# Access Compliance Report

## Public Rights-of-Way

Intersection ID: 43371	Main Street: BERNARDY_LN	Cross Street: SIMONTON_DR	Location: SW
ADA ID: 432A66032589	Ramp Type: PerpDiag	Initial Pass/Fail: Pass	Overall Compliance: No
		Severity Score: 0

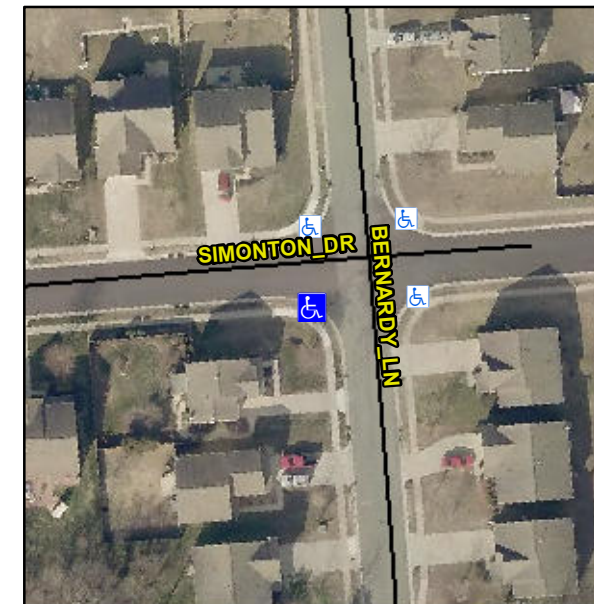
**Not Found, R304.5.3, R302.7**

**Remove & Replace Curb Ramp With Two New Directional Ramps or Equivalent.**
